**OHIO RIVER BRIDGES
SECTION 1 - KENNEDY INTERCHANGE
VALUE ENGINEERING STUDY REPORT**

Item Number 5-118.18 & 5-118.19

**Study Date: January 28 - February 1, 2008
Report Date: February 15, 2008**

**VALUE ENGINEERING STUDY
for
Kentucky Transportation Cabinet**

VALUE ENGINEERING RECOMMENDATION # VE-9

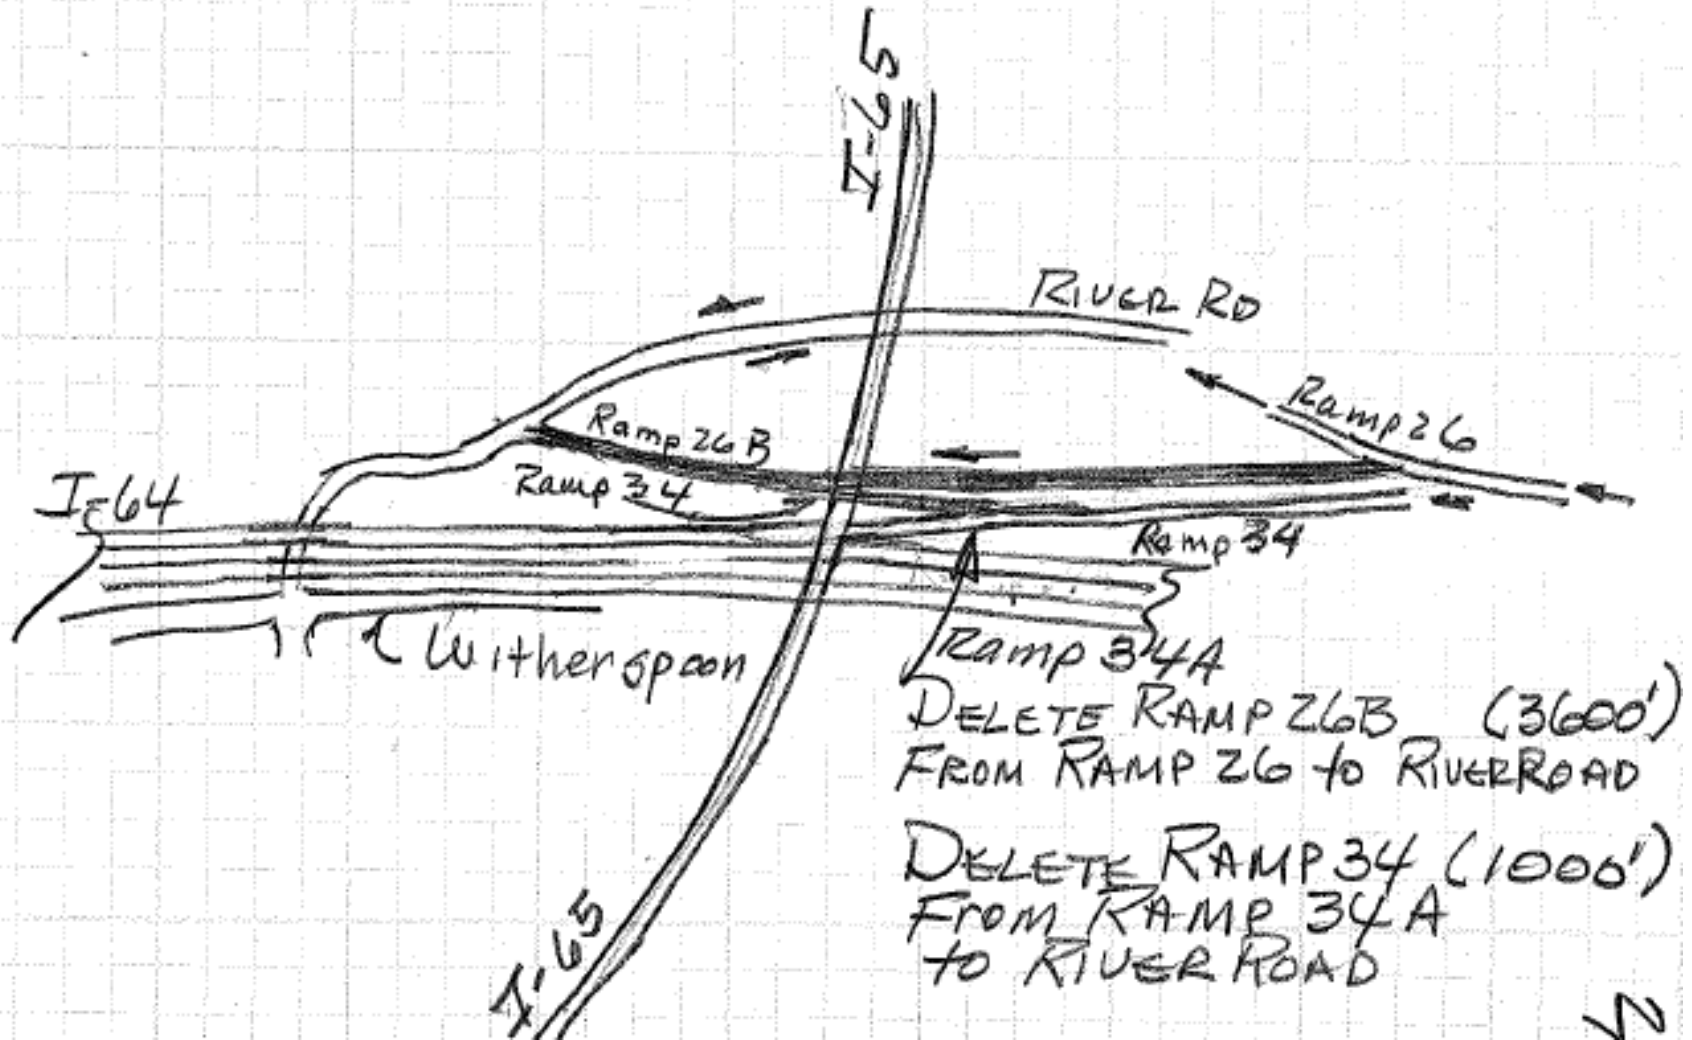
Connect BL-3 to Frankfort Road to provide access to River Road from westbound I-64, eliminate Ramp 26B from Ramp 26 to River Road, and eliminate Ramp 34 from Ramp 34A to River Road.

Provide a connection from westbound I-64 (BL-3) to Frankfort Road. Have southbound I-71 traffic exit at Ramp 31. Access to River Road will be by Frankfort Road. Eliminate Ramp 26B and Ramp 34 from Ramp 34A to River Road.

VALUE ENGINEERING RECOMMENDATION # VE-10

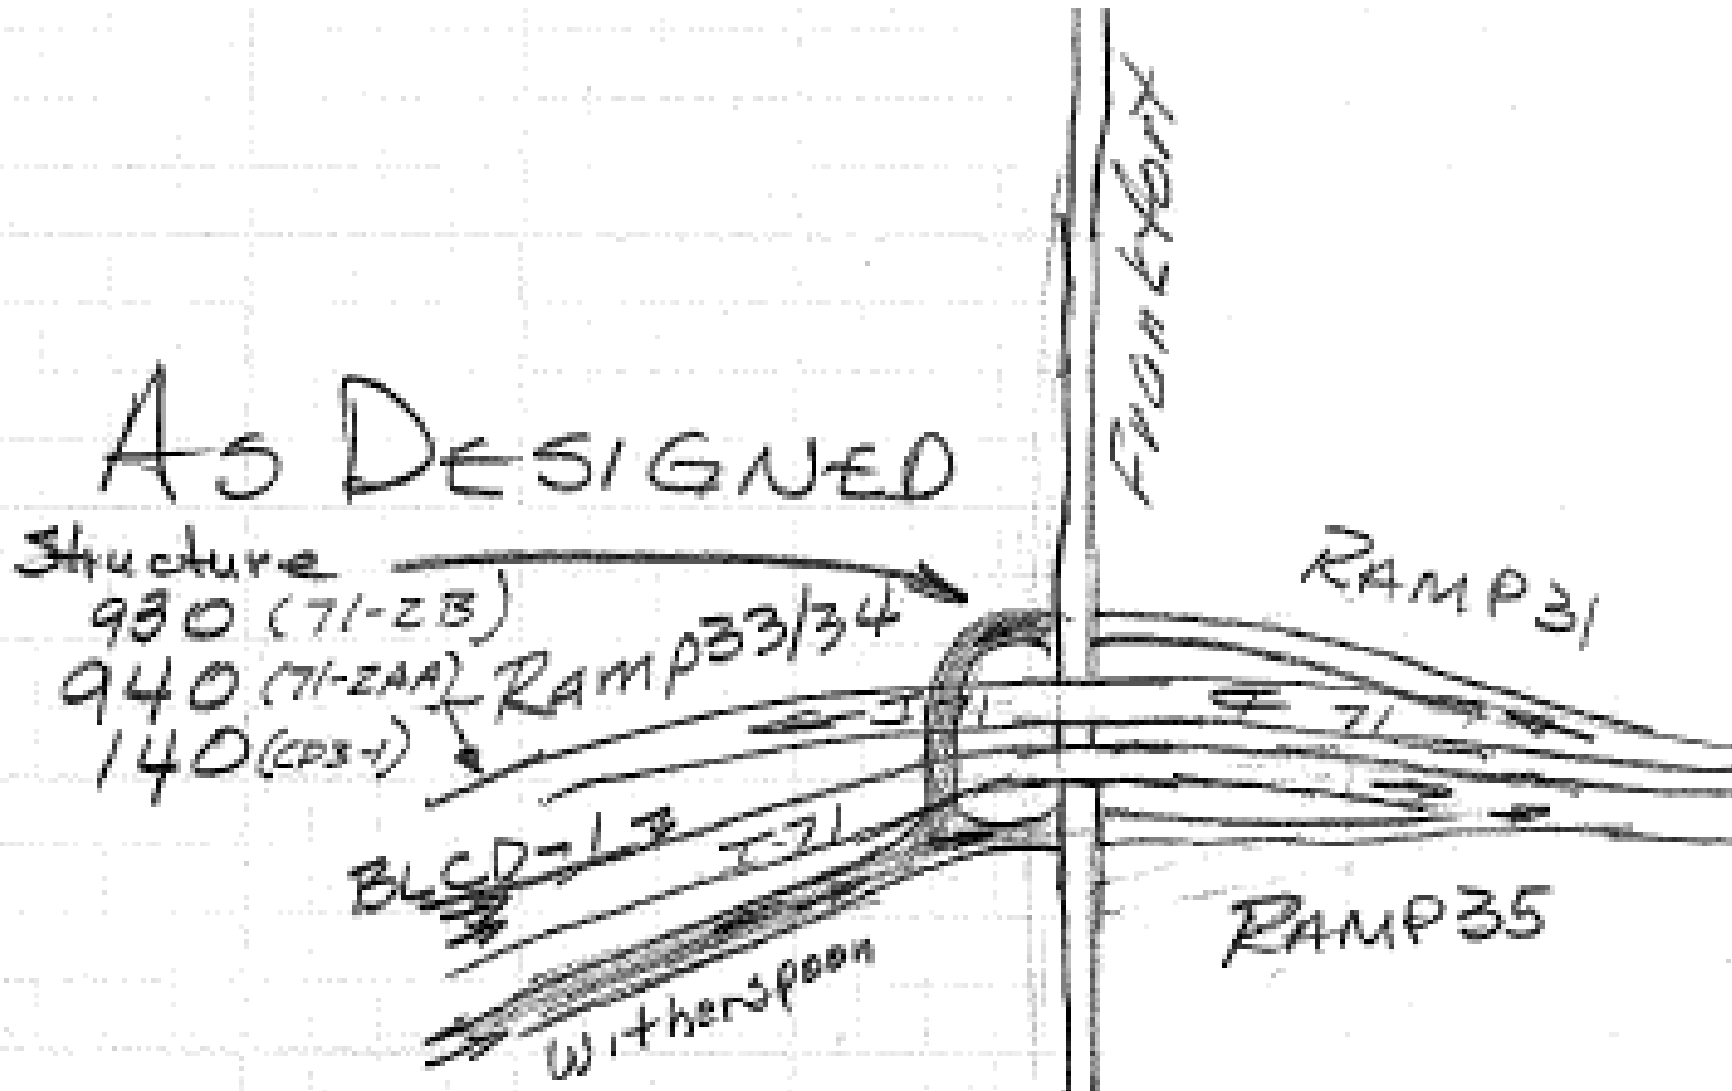
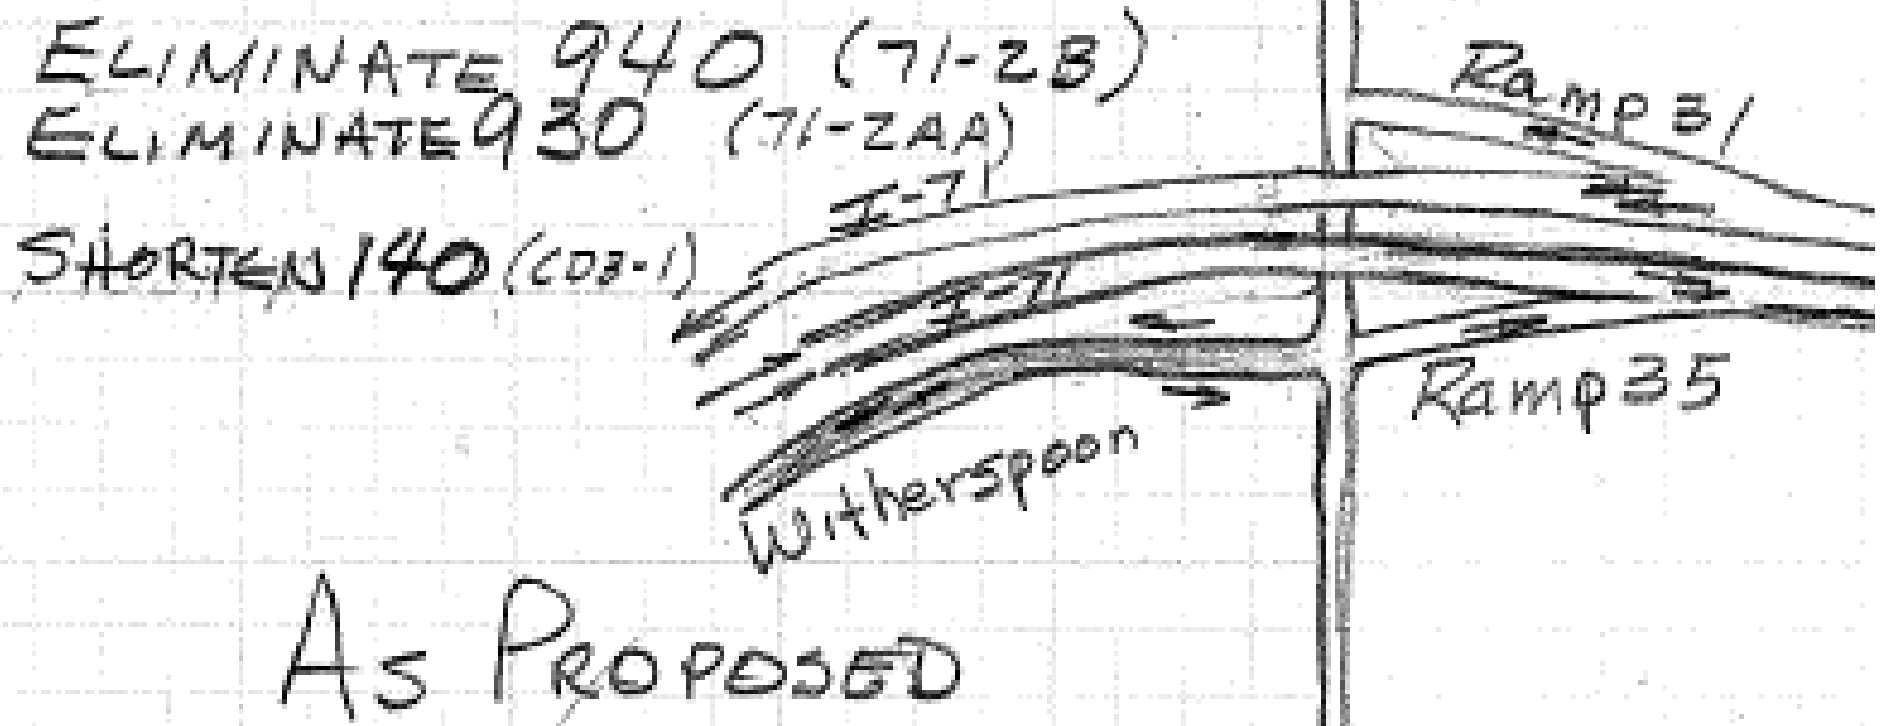
Extend BL-1 to the east parallel to BL-2 to Frankfort Road. Improve the intersection at Frankfort and BL-1/BL-2 to provide turning movements. Also improve the Frankfort and Ramp 31 intersection to provide for turn movements.

The current BL-1 currently goes under I-71 and Ramp 32. Bridges are required for I-71 and Ramp 32. The relocation of BL-1 will eliminate or shorten 3 bridges. The traffic movement will be altered from a through movement to a left turn.

VALUE ENGINEERING RECOMMENDATION # VE-13

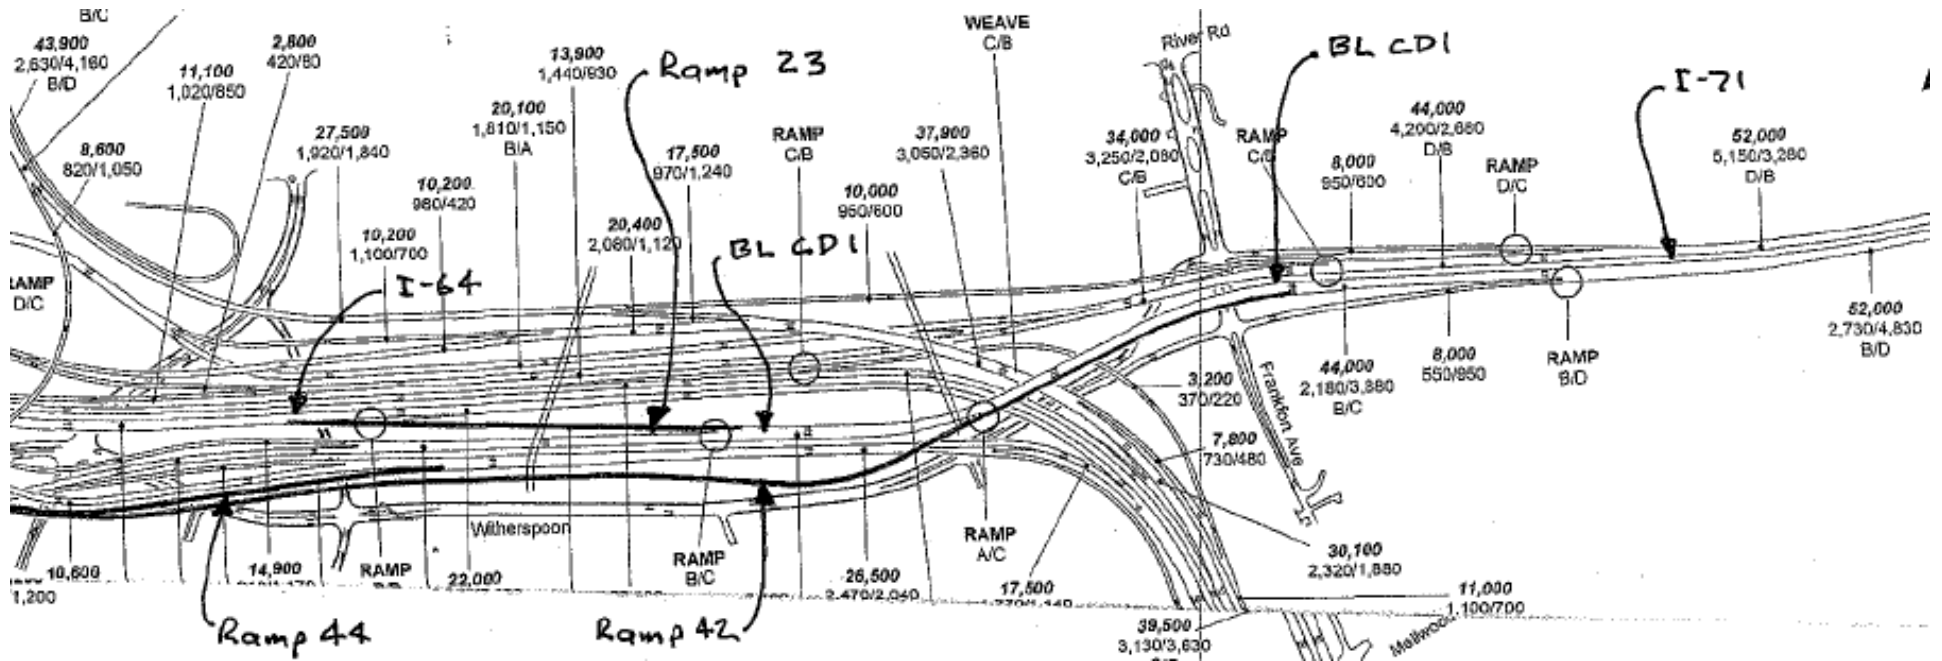
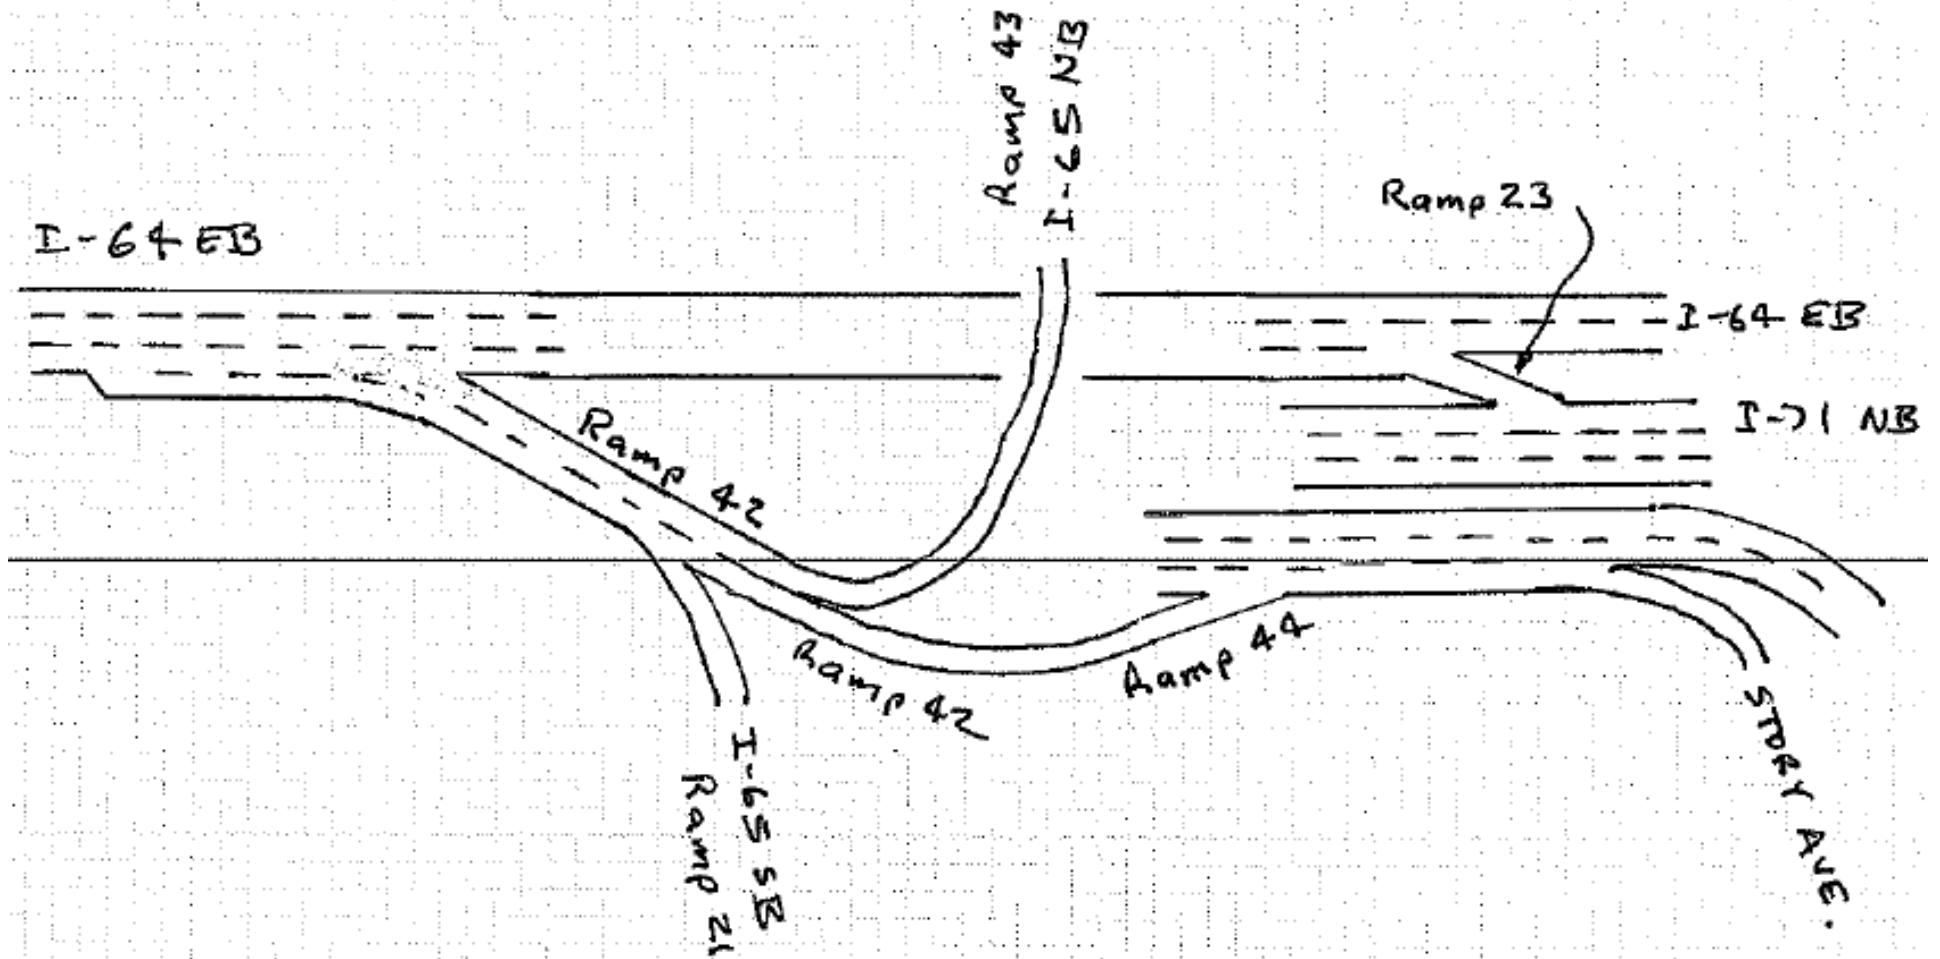
The ramp from 2nd Street is one of the lowest volume ramps in the project, but extends approximately 1.5 miles. Surface streets could be used to accommodate the traffic more efficiently. Also, making this change would reduce the impact of the project on the Great Lawn. The VE Team recommends that this change be made.

VALUE ENGINEERING RECOMMENDATION # VE-23

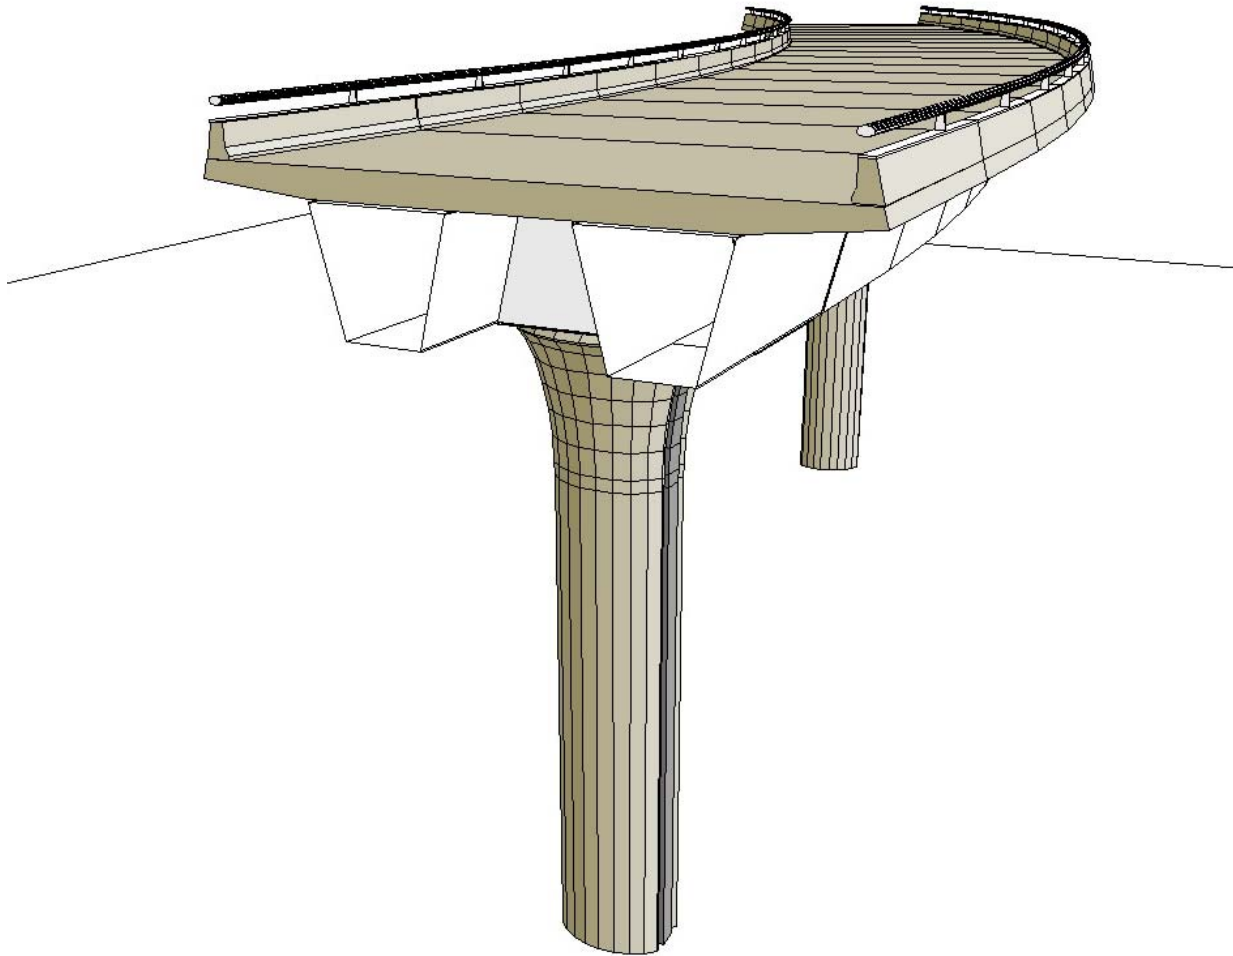
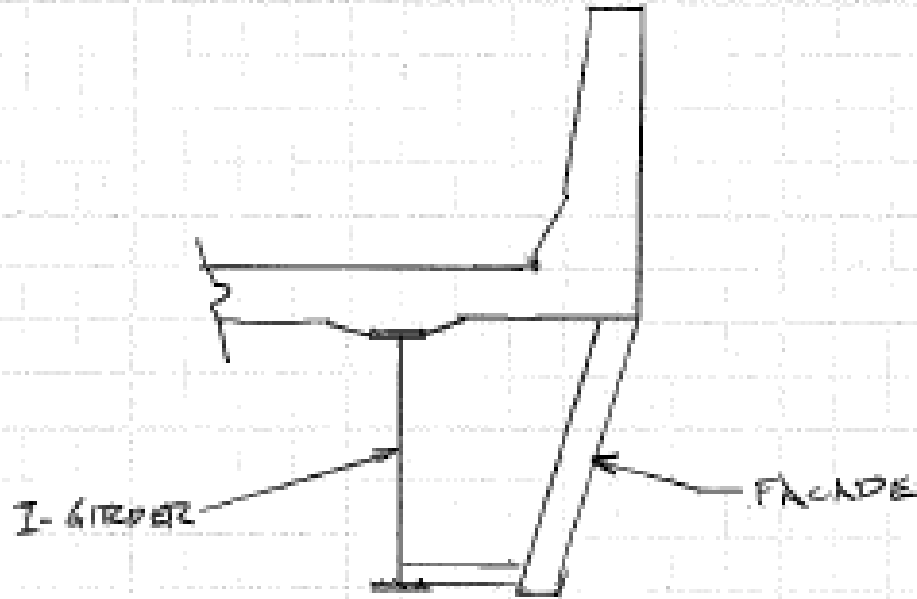
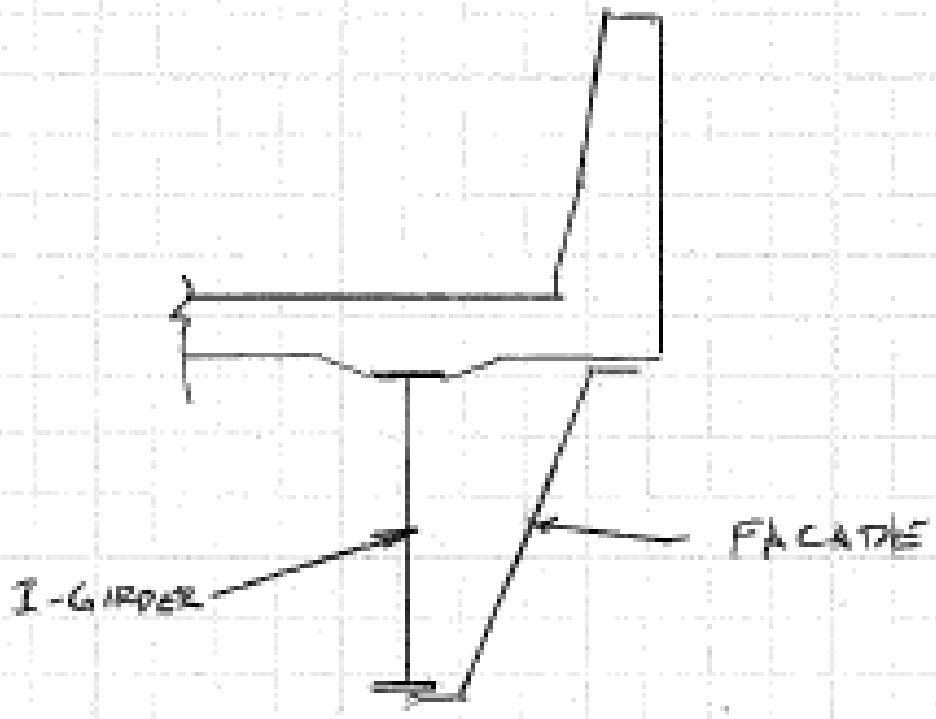
Use steel plate girder bridges instead of steel tub girders. Provide a façade to provide an aesthetically pleasing appearance and to hide the deck drainage and/or utilities.

The critical Structure Type Recommendations (Report Dates 7/27/2005) indicates that a premium of \$15 per square feet over all bridge deck area will be realized due to the use of steel tub girders. This alone is nearly 14% of the cost of the bridges and 7% of the total project cost of this section. Moreover the report refers to the need to provide structure depth greater than would otherwise be required and that these deeper structures were used to set the profile. This results in a hidden cost for approach roadway embankment as well as increases in superstructure heights and subsequent costs. The effect is even more than implied by the type study recommendations report because the main structure depth of 60 inches is correlated to a 150 feet span for the steel girder ($\text{span}/30 = 5' \text{ or } 60''$), however this limit is for a simple span bridge. In fact, the maximum span for a continuous girder (based on the distance between the inflection points) for a 60 inch girder is nearly 250 feet because $0.6 (250)/30 = 5 \text{ feet} = 60 \text{ inches}$.

In addition by their nature, the tubs are fracture critical and many of the fracture critical elements require inspection from the inside of the girders. The additional torsional capacity is of little value when two or more tubs are used. On the contrary, plate girders are highly redundant and easily inspected. They can provide minimum structural depth, and especially in situations where ramps are stacked, they will provide the least overall height and result in the biggest reduction of the “hidden” costs (i.e. increased substructure and embankment costs). Neglecting the hidden costs, this change would reduce the project cost by \$68.5 million while increasing the safety of the system.
